APPENDIX 7-8

Information Submitted in Compliance
With 30 CFR 77.216-1 and 30 CFR 77.216-2

Impoundment Name: Genwal Sedimentation Pond No. 1

COAL MRP AMENDMENT/FIELD DECISION FORM

PLATE 3-1

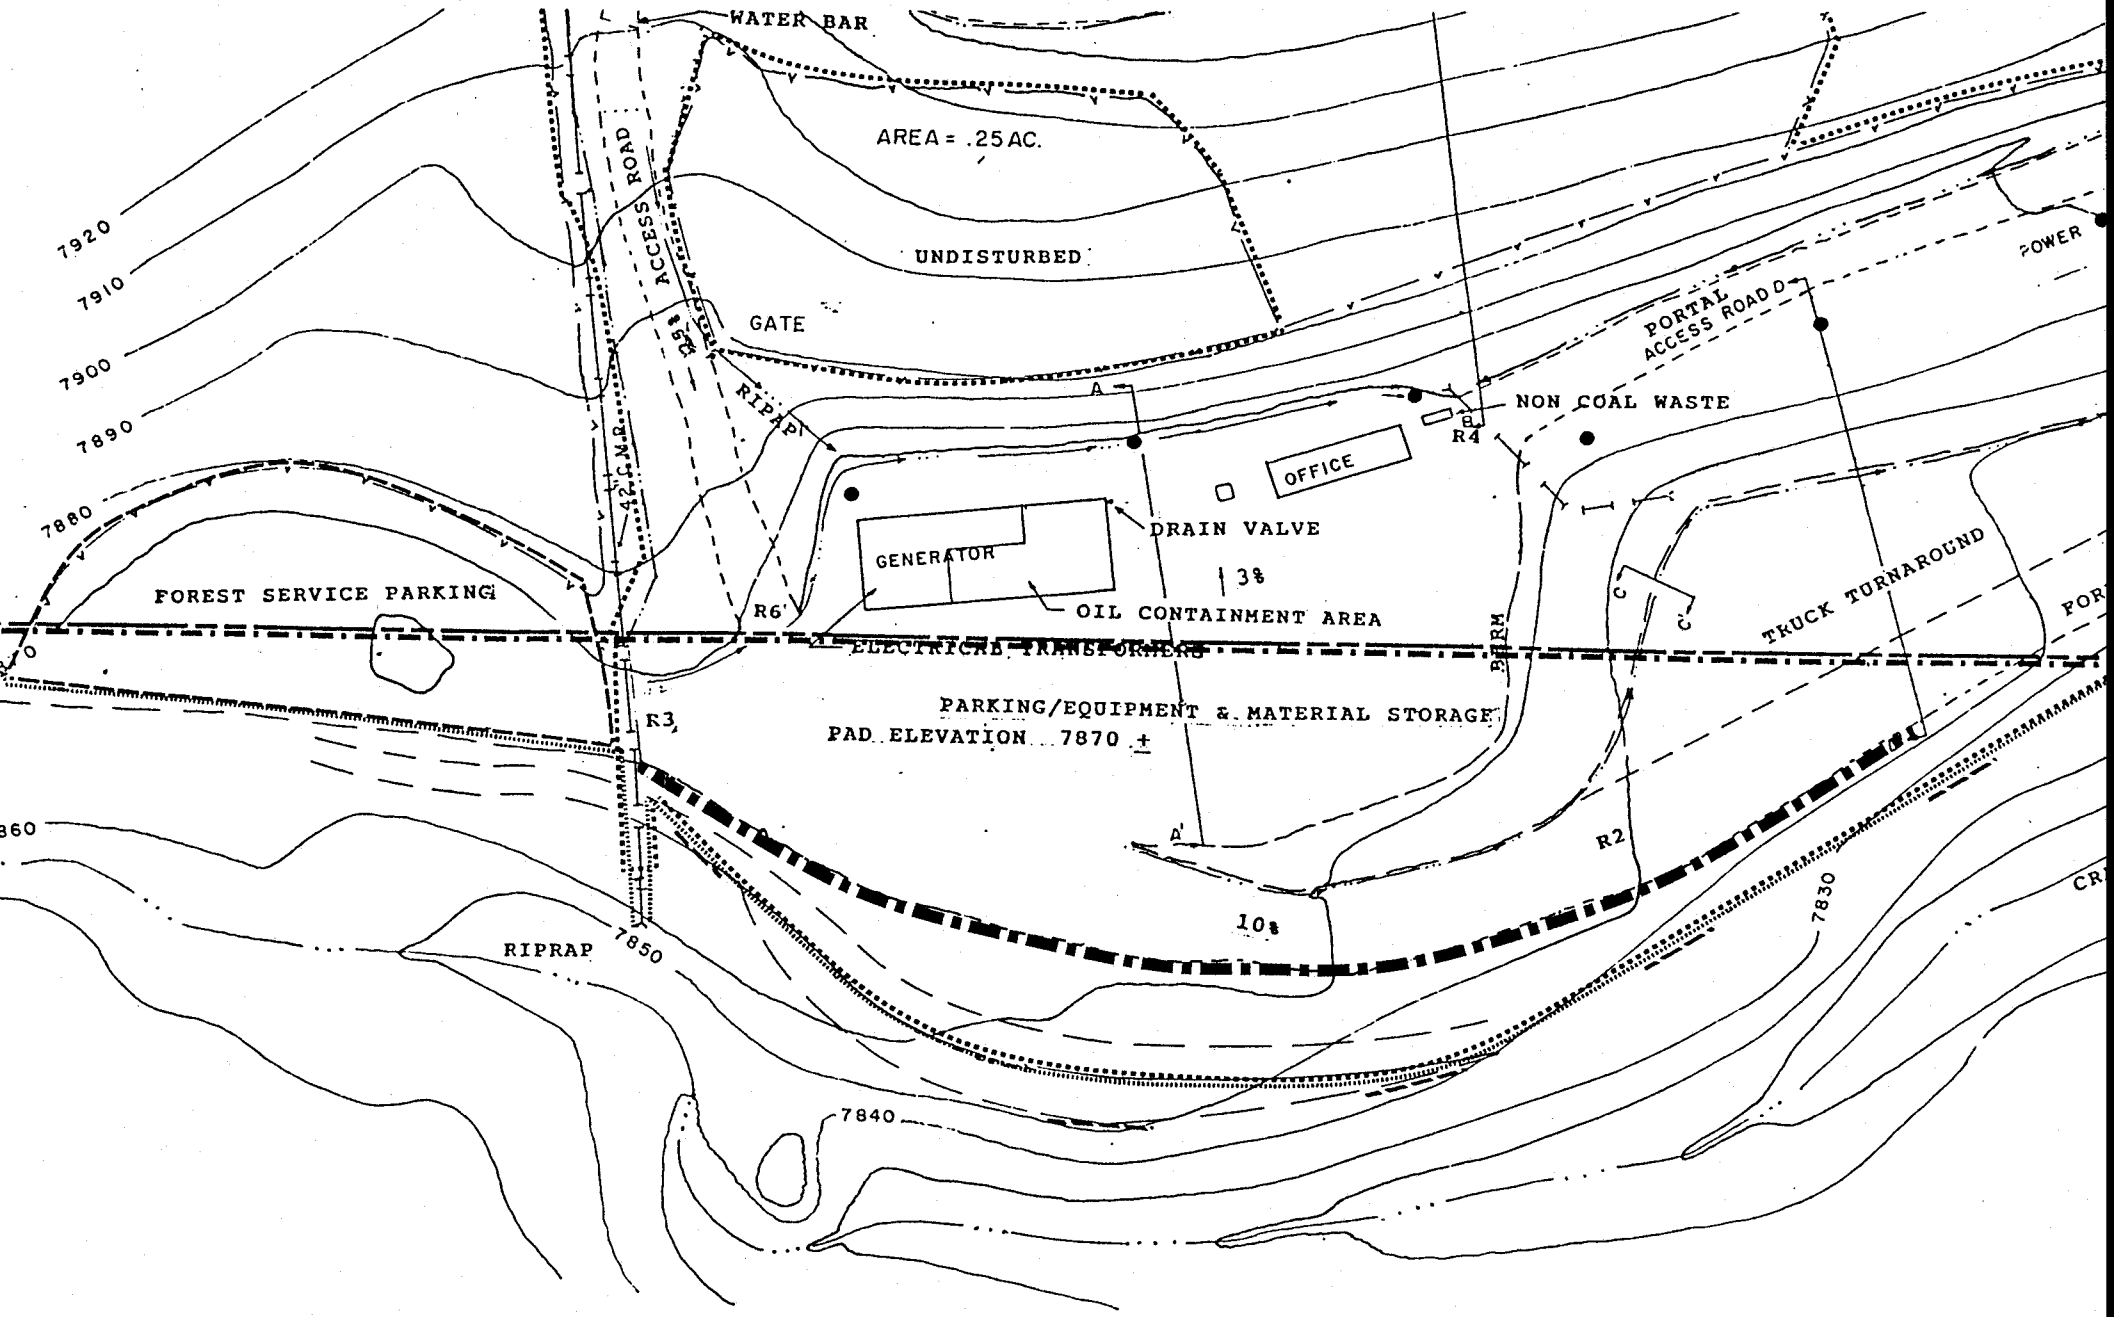
Description of Permit Change: Proposed Road Burm

Once a formal agreement between the Division of Oil, Gas and Mining and the United States Forest Service has been established pertaining to the placement of a roadside burm, Genwal Coal Company will commit to the construction and maintenance of a burm structure along the outside edge of the parking and storage area access road from the truck turn-around area west to the Forest Service parking area. (See enclosed Plate 3-1).

Genwal Coal Company will finalize plans and start construction of burm when notified of the Division of Oil, Gas & Mining and the United States Forest Service's decision.
